Enclosed Defect REPORT (hereinafter called the "Report")

Inspection Date: 18/12/2019

Property Address: Sample

New Construction

1. Brick over-hang. This will need to be rectified.

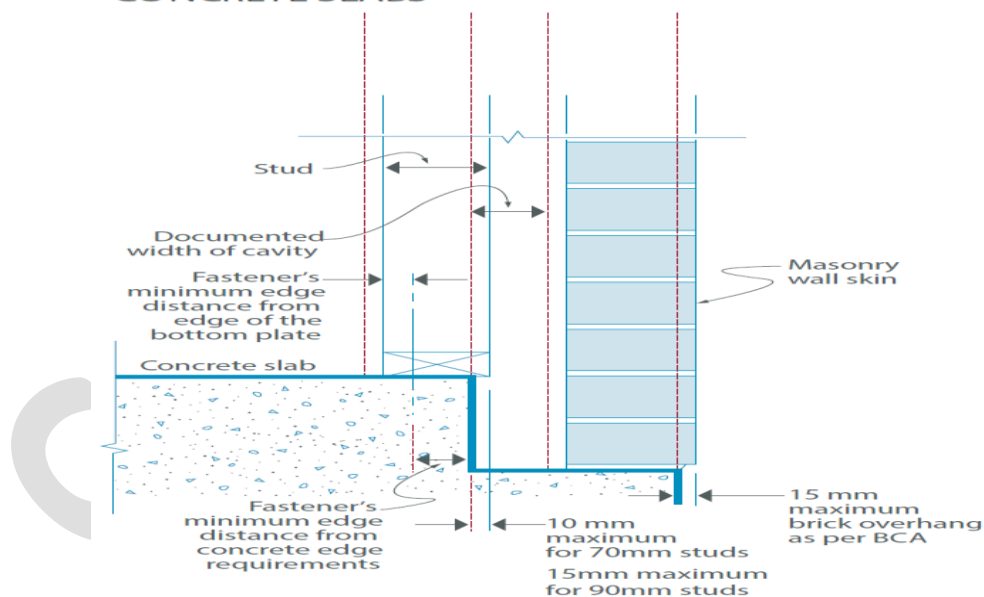
The brick over hang to the dwelling needs to be supported. The BCA, part 3.2.2.7 calls for a maximum overhang of 15 mm. All must be reworked and supported in accordance with AS 2870 prior to handover.

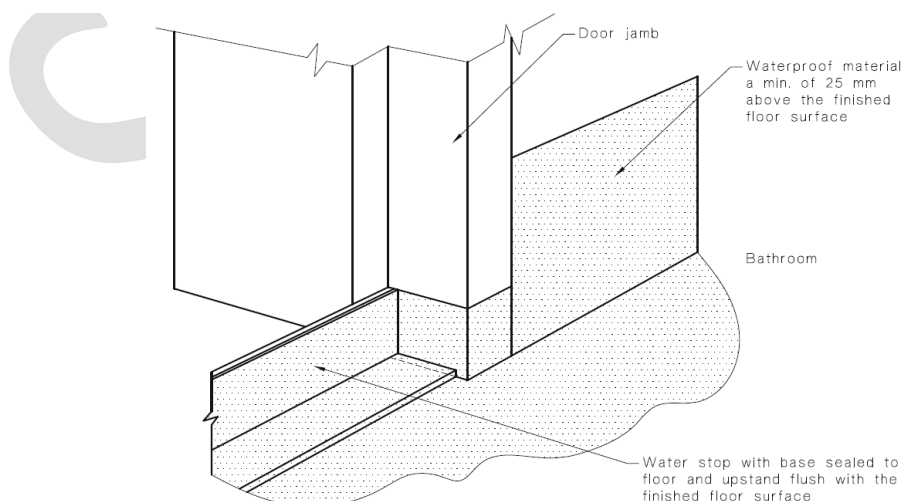
11. It was noted at the time of the inspection that it appears that there as been no water stop installed to the openings of some of the bathrooms, this will need to be rectified to comply with the minimum standard, refer to insert below.

- (a) *For whole wet area floor waterproofing* A water stop that has a vertical leg finishing flush with the top of the finished floor level shall be installed at floor level openings. The floor membrane shall be terminated to create a waterproof seal to the water stop and to the perimeter flashing.

FIGURE 3.4 TYPICAL DETAIL FOR RECESSED SOAP HOLDERS

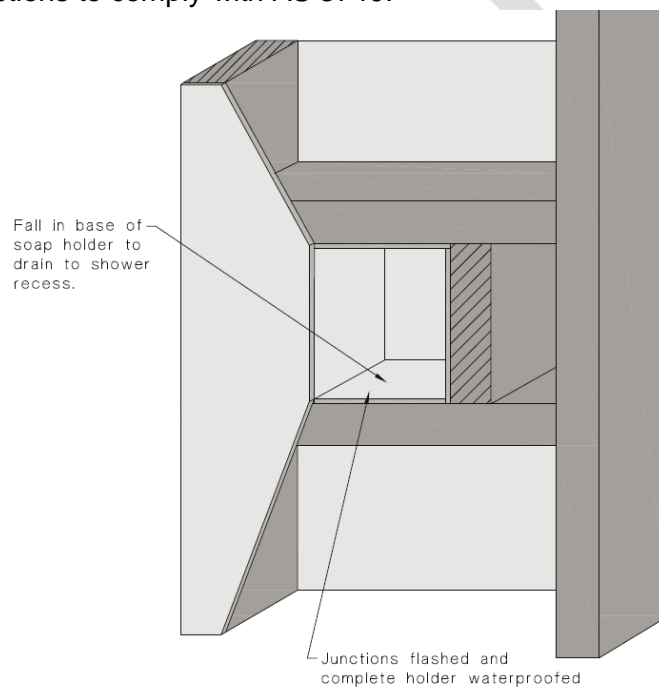
12. The niche sections to the shower have not been constructed with sufficient fall. The builder must rework these sections to comply with AS 3740.
